Martin Place, Overstation Development, North Site

Architectural Design Statement

Rev 01, 28/05/20

1. Increased depth to Level 10 eastern external terrace; and,
2. Raised service access floor to Levels 3 and 4.

Approved Level 10 Eastern façade setback

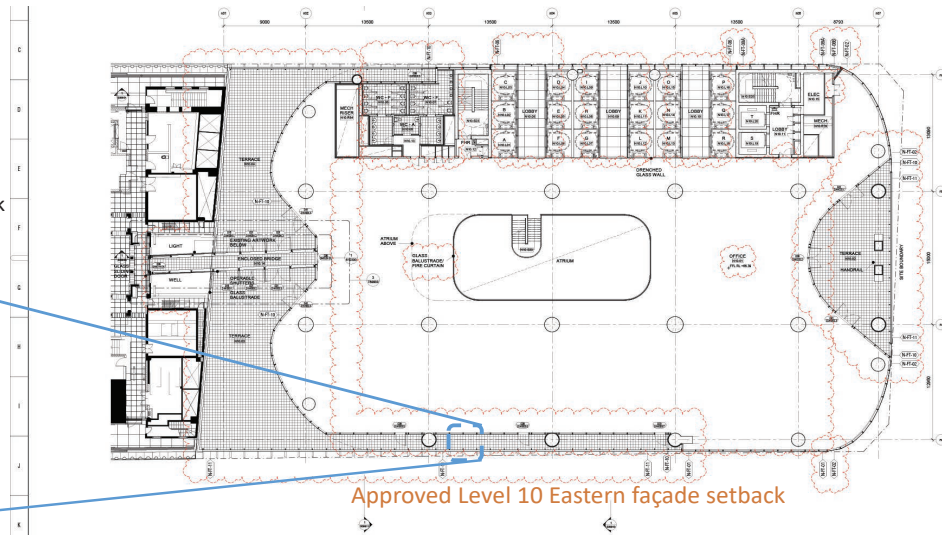
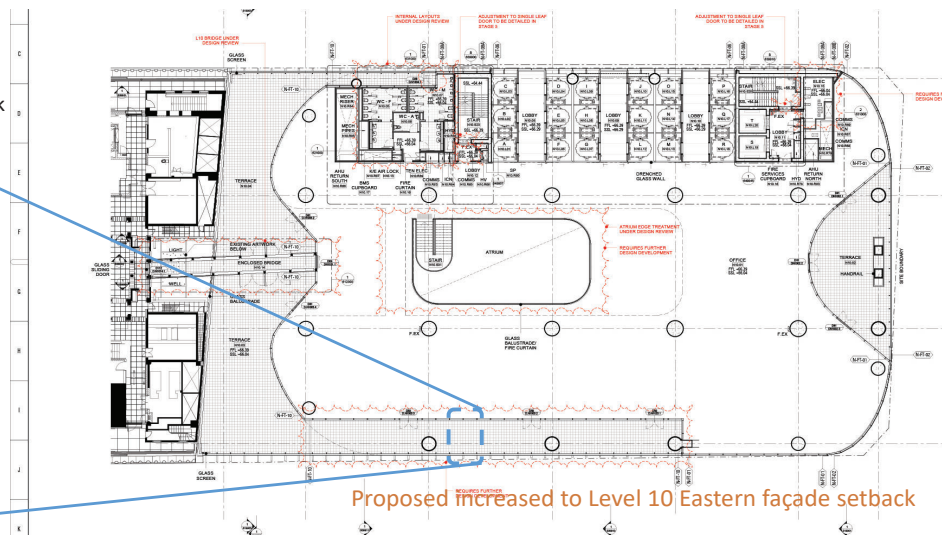
1. Increased depth to L10 eastern external terrace

The L10 Eastern Facade Setback was introduced as a recess in the tower curtain wall facade to visually transition the Hunter Street 'tower to ground' form into an articulated podium at the southern boundary as a parapet that aligns to the height of the predominant street wall and respond to the scale of 50 Martin Place.

Macquarie have subsequently developed their approach to their Level 10 Client Floor to more directly integrate the interior with the external landscape terraces including this proposed modification to increase the eastern facade setback as a deeper and more useable landscaped terrace.

This modification is consistent with the original architectural intent and the deeper setback assists the articulation of the podium and adds to the interest, amenity and uniqueness of this Client Floor.

Developed Drawing
L10 eastern façade setback
to align with inner column
face

Proposal
L10 eastern façade setback
3785 mm

Proposed increased to Level 10 Eastern façade setback

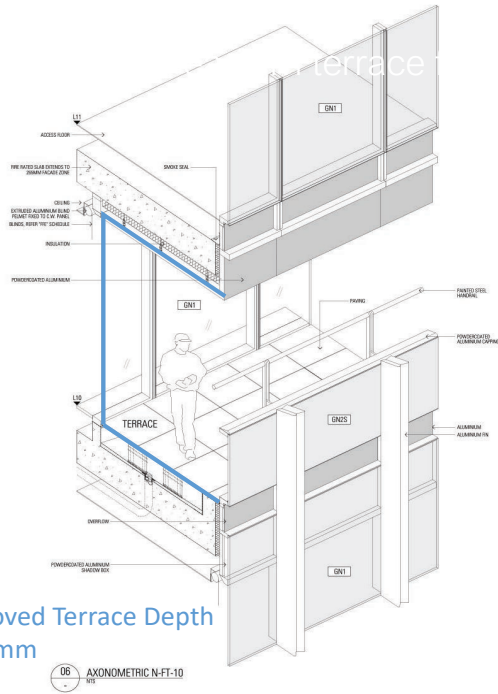
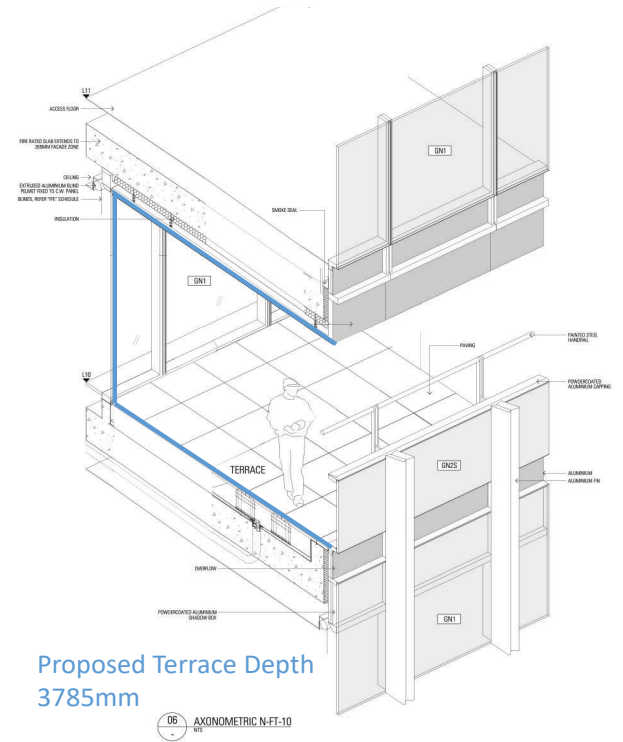
Approved Terrace Depth
1835mm

Proposed Terrace Depth
3785mm

Recap: Tower form, articulation and interface DRP 08 – 25.02.19

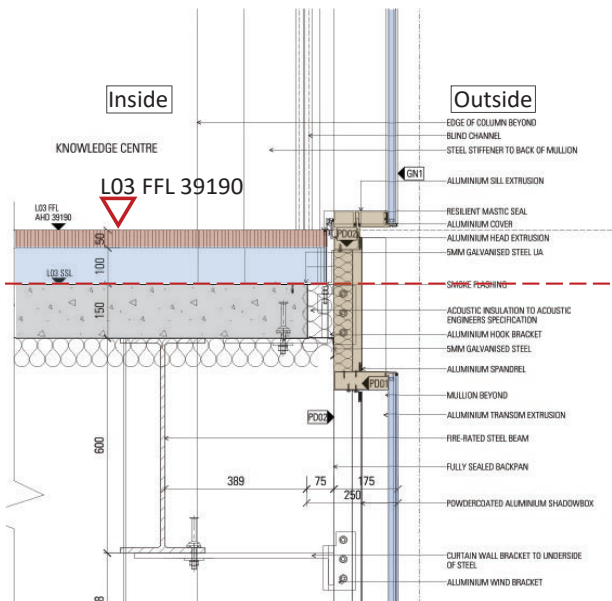
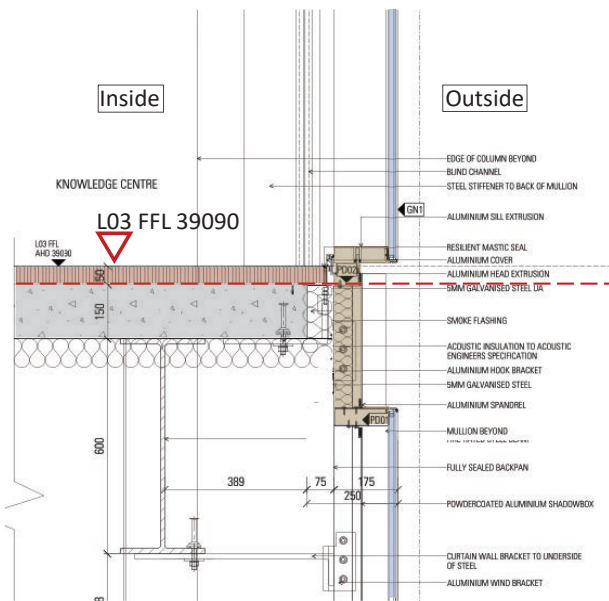
'Tower to ground' form responds to the alignment and cluster of existing Towers on Hunter Street

Deeper recess results in No change to image

The Tower transitions into an articulated podium at the southern boundary to reinforce the street wall, and respond to scale of 50 Martin Place

Legibility of 50 Martin Place as a prominent palazzo form
